As part of the quality control checks for the NHDPlusHR as well as in preparation for the development of Elevation Derived Hydrography (EDH) at scales finer than 1:24,000, the USGS is reviewing the delineations of the WBD Sub-basins (HU8s). The USGS is looking for inherited errors that were propagated through the WBD based on the original source data, a 1:250K dataset, and to ensure that the Sub-basin delineations make hydrologic sense based on coding and names. Several boundary adjustments to the Idaho Falls (17040201) HU8 have been identified during that process. These changes may have far reaching effects as many project boundaries are described by Sub-basin.

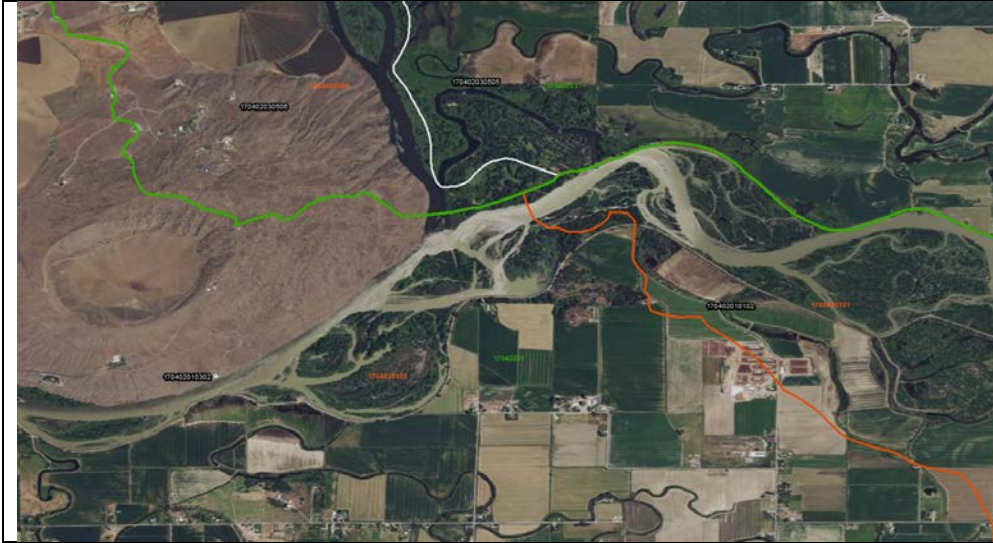
It appears that the original 8-digit boundary for 17040104 was based on the HUC250K dataset which breaks at a minor tributary. Propose to adjust boundary to a more predominant feature like the confluence upstream with Antelope Creek (Option 1) or the downstream diversion into Dry Bed Canal (Option 2).
